URGENT FIELD SAFETY NOTICE/ MITRACLIP/ PHYSICIAN ADVISORY

COMMERCIAL NAME: MitraClip Clip Delivery System
FS CA-Identifier: February 4, 2016
Type of Action: Advice regarding the use of the device

Abbott Vascular is voluntarily issuing this Field Safety Notice for the MitraClip Clip Delivery System, product number MSK02ST. The MitraClip System contains the Clip Delivery System, product number CDS02ST, and the Steerable Guide Catheter, product number SGC01ST.

Figure 1, DC Handle

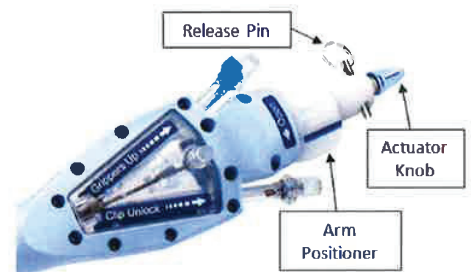
The following contains the revised instructions. It delineates what is changing and explains the step's importance in eliminating tension. Two figures accompany the table; Figure 1 annotates the relevant components, and Figure 2 provides a visual cue that demonstrates system tension is relieved.

- 12.2.2 Turn the Arm Positioner in the "Open" direction until the Release Pin groove is fully exposed.
Note: After the Release Pin is removed, turning the Arm Positioner in the "Open" direction will not open the Clip Arms.

The revisions, which are identifiable within the boxed text, ensure tension is fully removed from the system before deploying the Clip from the Delivery Catheter. They also provide a visual cue (exposed Release Pin groove in Figure 2) to verify the device is not storing tension.
